SEWAGE DISPOSAL SYSTEM

HOWARD COUNTY HEALTH DEPARTMENT

SUBDIVISION Brantwood 2/1 LOT NUMBER 19 ADDRESS 3001 Seneca Chief Trail

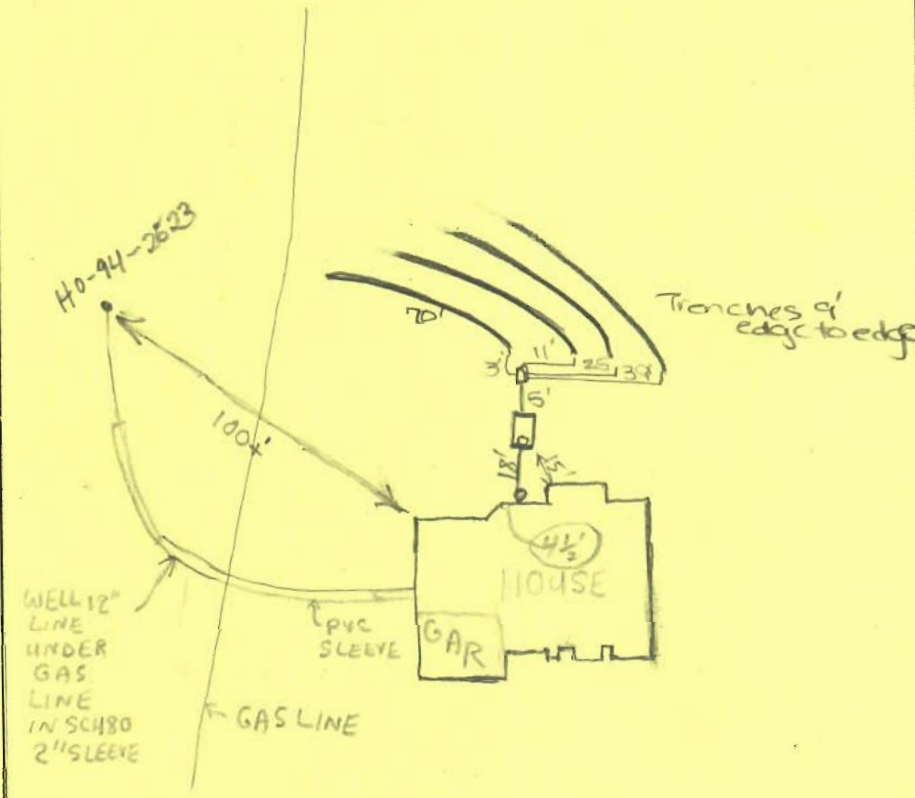
Will need a pump system, plumbing coming out under patio.

PRE-CONSTRUCTION INSPECTION: Site Needs a new Survey. Stake out 100' to well reading, proposed pool,

and newly raised SDA to demonstrate rough initial and 2 replacement septic systems (shallow Standard Trenches only) and SWH pond, and on fall stream - SDA markers, fill fence in partly down. - Open appears to S well for 810 LF of Trenches. 2/12/01

INSPECTION COMMENTS: 2/12/01 Above issues resolved, replacement septic systems only need 180 @ per bdrm. 2/14/01 To install system as shown on BP plan. (BB)

Septic Tank Home Construction OK, Baffled "T" manholes/S.T. (line is gravel bedded) R/P 2/21/01

2/26/01 Final Inspection - OK to cover all septic work. DIC

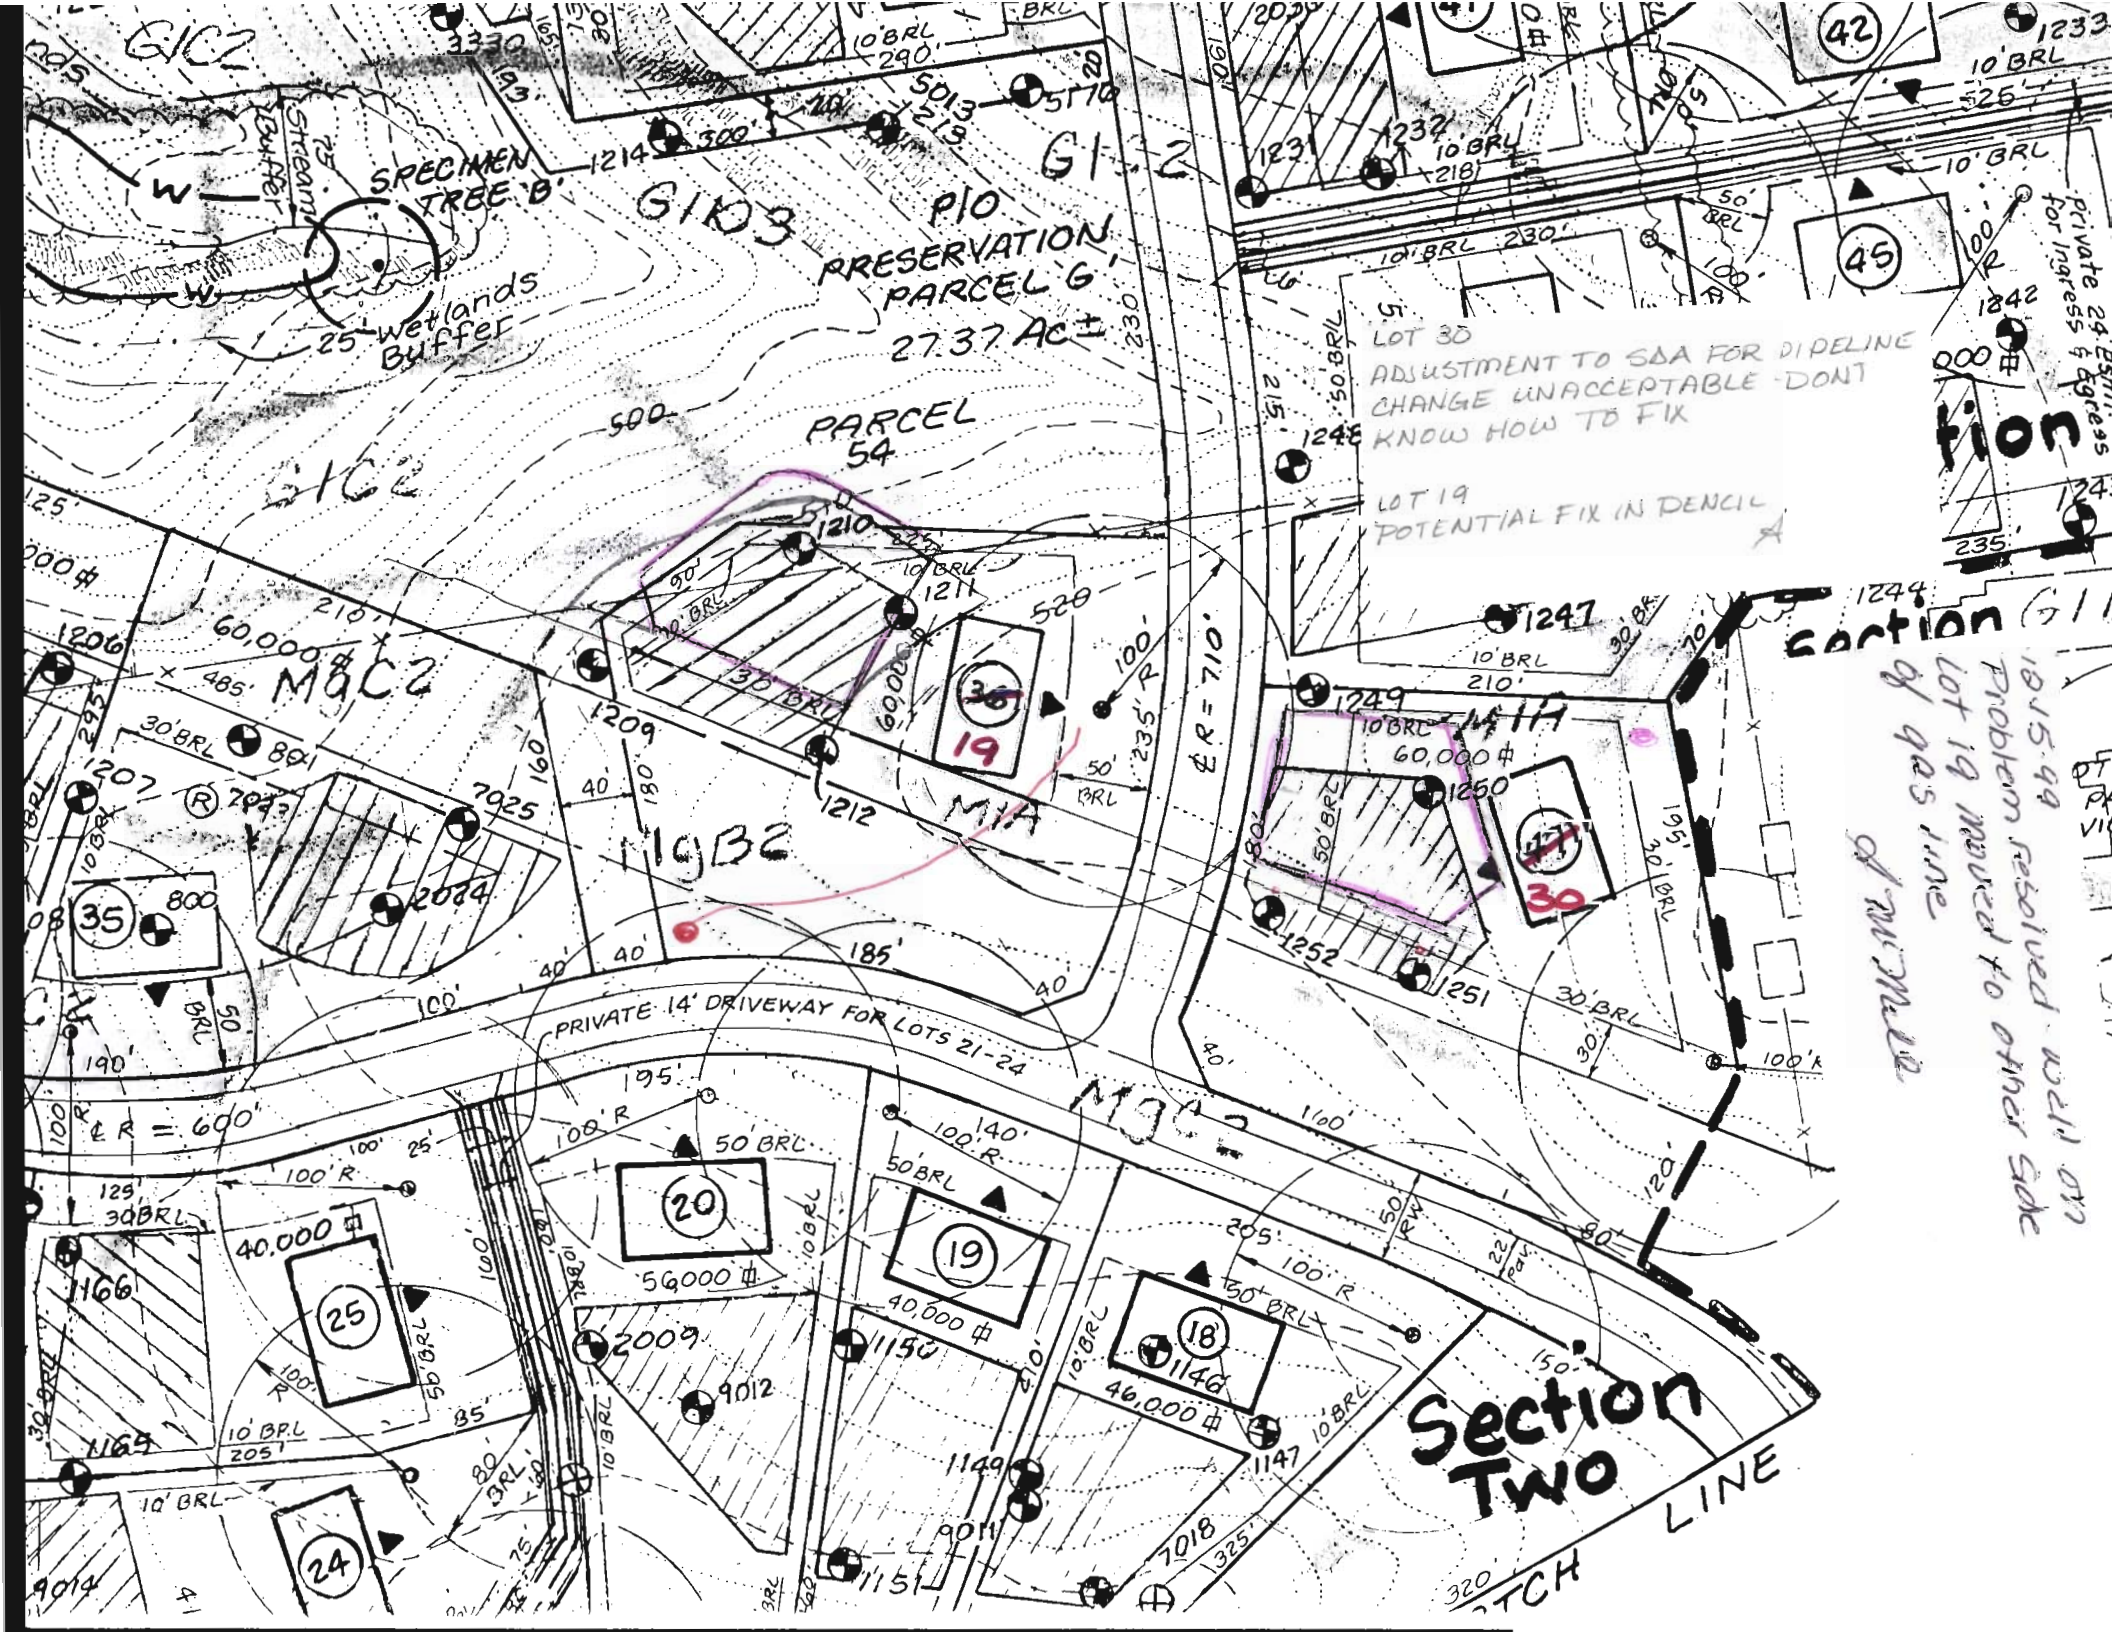
LOT 30
ADJUSTMENT TO SDA FOR PIPELINE
CHANGE UNACCEPTABLE - DONT
KNOW HOW TO FIX

LOT 19
POTENTIAL FIX IN DENCIL

1815-99
Problem resolved 10/21/07
lot 19 moved to other side
of gas line
